**CanWhite Sands – Sand Processing Facility Environment Act Proposal – File No. 6057.00**

**Public Comments Received From:**

Risk Assessment of CanWhite Vivian Sands Project Environmental Assessment Plan (EAP) Processing Plant Public Registry # 6057 – for Our Line in the Sand

**Figure 5.** Shale fragments in the sand extracted by CanWhite exploration solution mining near Vivian.

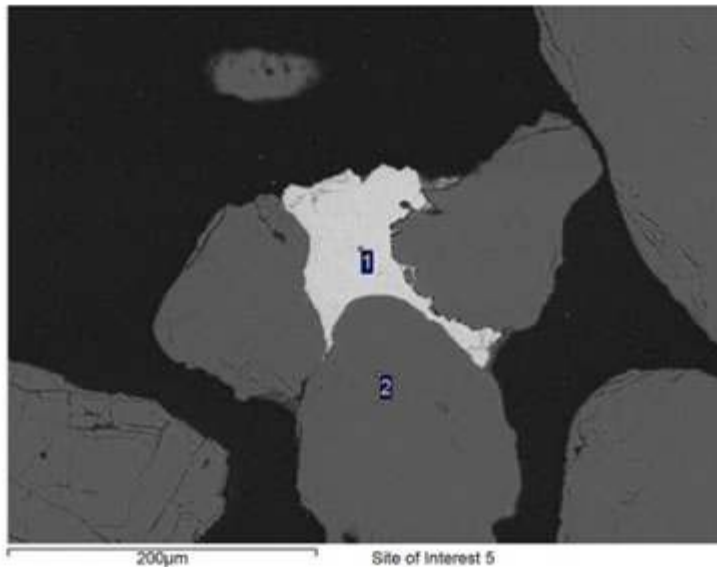
The same shale fragments that are shown cascading down the sand faces at Black Island were found in the CanWhite sand piles extracted by exploration solution mining near Vivian as shown in figure 5 .

This shale verifies that the shale layer overlying the sand in the Vivian area is extracted and brought to the surface along with the sand by the CanWhite solution mining method. The purple shale is consistent with the illustration of figure 3. The shale will begin to oxidize in the aquifer when exposed to the air used in the sand extraction. Heavy metal and contamination of the aquifer will occur even before the sand is extracted.

The shale shown above will be in the slurry carried to the Vivian sand processing facility. Oxidation will occur in the slurry lines, the wash plant and the clarifier contaminating the slurry water with heavy metals, iron and acid. The shale fragments will likely end up as over sized fragments screened into in the over/fine sand stockpile outdoors shown in the EAP.

**Figure 14.** Topographical map of Vivian area showing the natural drainage path to the Brokenhead River.

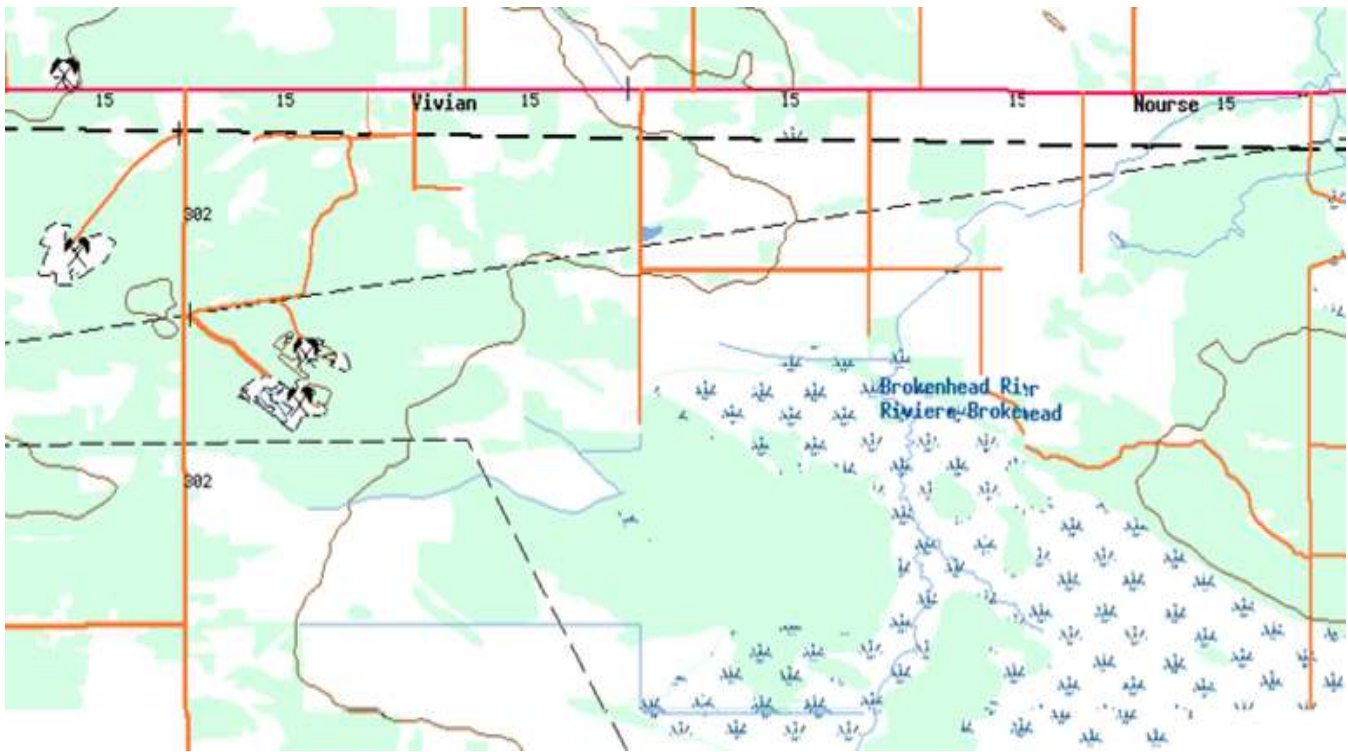
aquifer the may evaporate in the clarifier but most of the 7.7-0.2= 7.5 million cubic meters of water appears to be surplus. 7.5 million cubic meters will cover the 17 hectare plant cleared area to a depth of at least 44 meters. The EAP sates that excess water will be stored in an outdoor storage tank shown in figure 2-2 of EAP part 1. This tank is far too small to accommodate the 7.5 million cubic meters of excess water. The only reasonable conclusion is that the water will be discharged on site to follow the natural drainage path to the Brokehead River about 3.5 kilometres to the southeast as illustrated in the topographical map shown in figure 14.

This would suggest that any released water would follow natural drainage. The statement that the wet process will not discharge water to the land surface does not appear to be credible. The large volume of extracted water must go somewhere and no dedicated culvert or drainage ditch is in the EAP plans to carry this volume of excess water. Some of the water containing acid and heavy metals will be expected to infiltrate into the carbonate aquifer as it drains. This is discussed further in section 5.

**Figure 18.** Well design to isolate the Winnipeg formation from the carbonate aquifer above.  
<http://www.manitoba.ca/sd/////waterstewardship/reports/groundwater/resources/cookscreek.pdf>

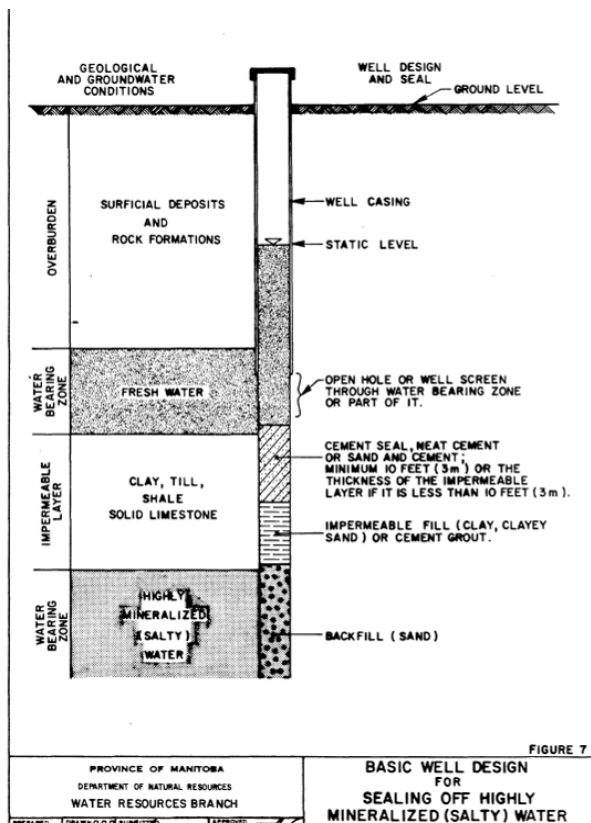
The sealing requirements for the shale layer above the Winnipeg formation is illustrated in figure 18.

It has been demonstrated that the solution mining and subsidence will destroy the shale layer making sealing of the shale layer around the CanWhite boreholes impossible.

**Figure A1.** AECOM modelling of PM<sub>10</sub> concentrations from the sand processing facility at Wanipigow reproduced from the CPS EAP showing exceedances up to one kilometre north of the plant.

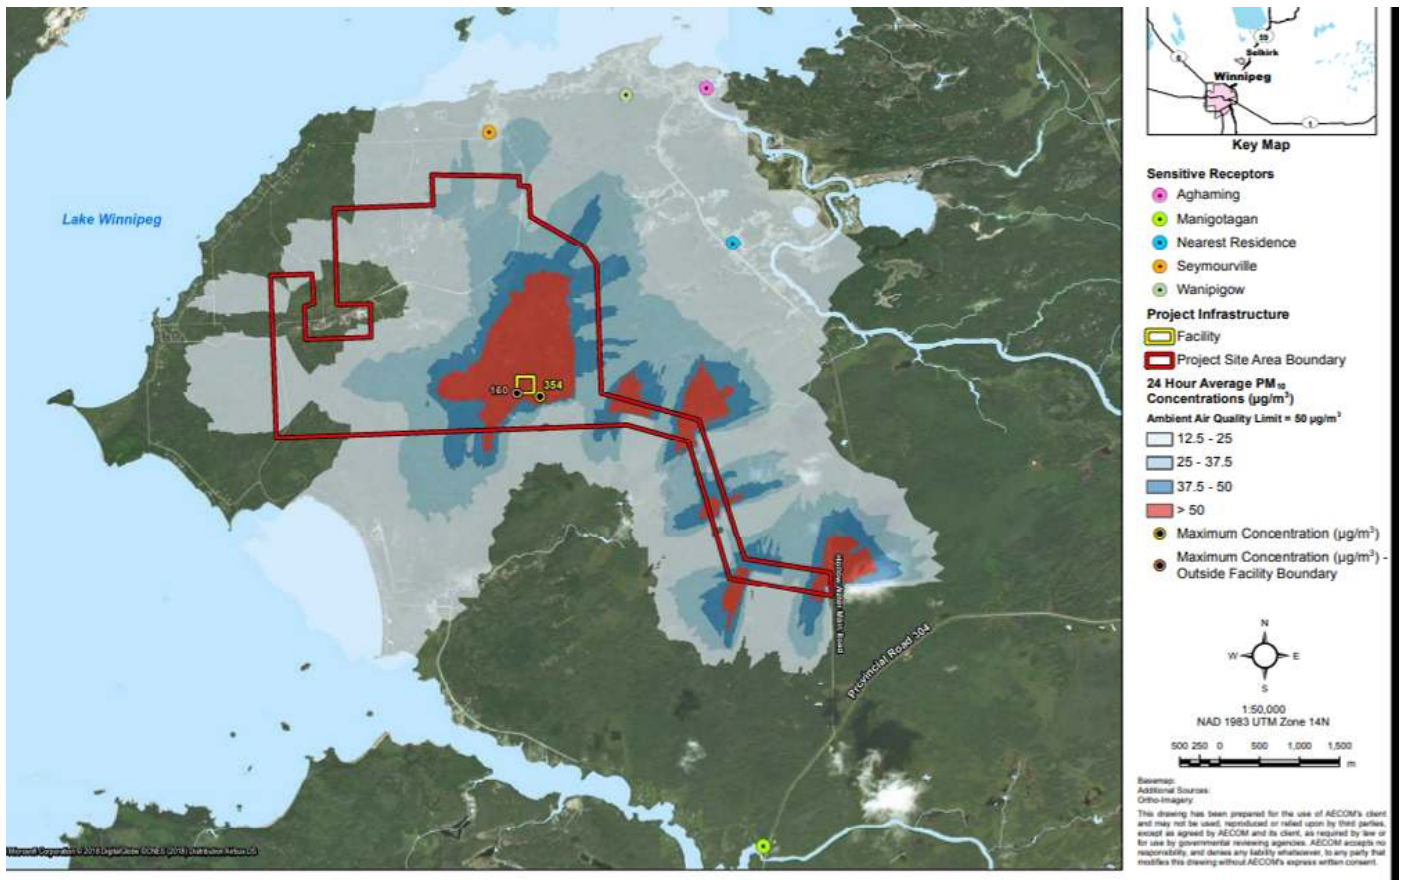
The largest emitters according to the AECOM modelling at Wanipigow reproduced in figure A2 was from material handling activities of loaders, dump trucks and a dozer. Similar material handling activities will be required at Vivian. One could argue that the lower amount of fines in the sand from the wash plant being handled at Vivian rather than raw sand at Wanipigow would result in lower emission rates Vivian. However the material handling equations specified by Environment Canada and the EPA shown below do not contain any terms for the percentage of fines.

The method and equations used for determination of the rates from figure A2 at Wanipigow were not documented.

AECOM modelling from Wanipigow suggests that the air dispersion modelling for material handling may be underestimated for Vivian. The material handling releases at Vivian may be less than Wanipigow because no raw sand is handled at Vivian. However the equations specified for material handling by the EPA and EC (the equations are the same) do not have terms for fines content. Judgement factors were likely used for efficiencies at Vivian that were not applied Wanipigow. No detail of the material handling modelling was given in the EAP at Wanipigow so no determination can be made as to the reason for the higher releases from material handling near the plant site at Wanipigow compared to Vivian. This type of modelling is subject to large uncertainties and cannot be relied upon for such a critical health risk. Real time air monitoring is essential to limit the risk of exposure to nearby residents.

**Figure A12.** PM10 downwind concentrations for the baghouse stack for various wind speeds, baghouse efficiency and sand fines content

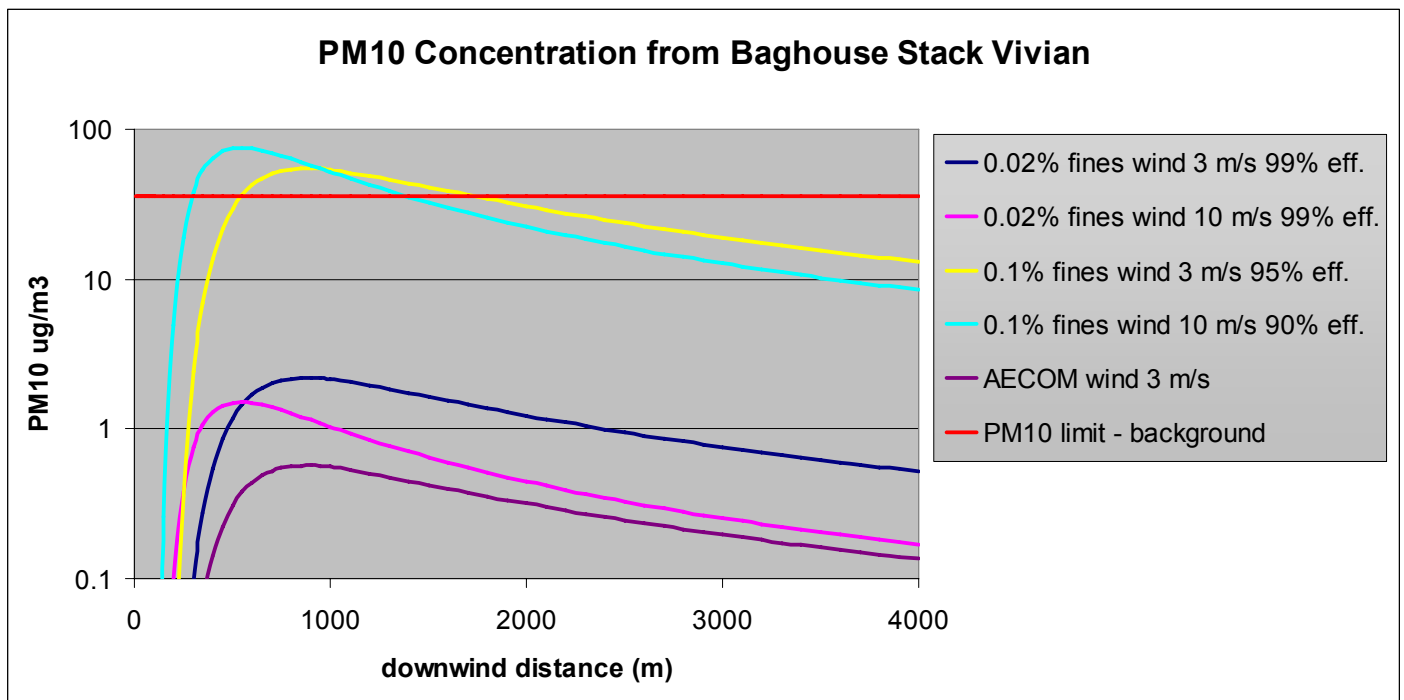
The last three entries in Table 1 illustrate that baghouse stack has the potential to be the largest emission source. All the emission source data for the stacks given by AECOM appear to be unsupported. The last three entries based on baghouse efficiency, and fines content suggest that baghouse stack emission rate used by AECOM (or the dryer stack emission rate) is a large underestimate.

Simple Gaussian plume dispersion modelling from the baghouse stack alone demonstrate shown in figure A12 that exceedances to nearby residents can occur for a fines content of about 0.1 percent or more in the sand sent to the dry pan and for a baghouse with an efficiency of 95% or less. Baghouse efficiencies can decrease with time and require routine maintenance. Fines content can vary substantially for different sand samples as shown in the figures above. The exceedances due to the baghouse stack alone can persist up to two kilometres. The contour plot of figure A13 using AECOM data for the stack releases and EC equations for material handling with no efficiency factor applied give no exceedances. When the baghouse efficiency of 90% and a fines content of 0.1% the contour plot shown in figure A14 The contour plots of figure A14 show exceedances as expected from the plots of baghouse stack release alone. The exceedance area is relatively narrow. As the wind shifts the exposure area will shift.

The stack release plots of figure A12 illustrate the exceedances are relatively insensitive to wind speed. The reason for this is that the effective stack height diminishes with increasing wind speed due to the bent over plume phenomenon for most air stability conditions. This means that overexposures can be relatively persistent cycling with wind direction. An examination of Google maps indicates that about 20 – 30 residences may be within reach of plume exceedances.

The modelling done in this report illustrates that exceedances can occur from the baghouse stack alone.
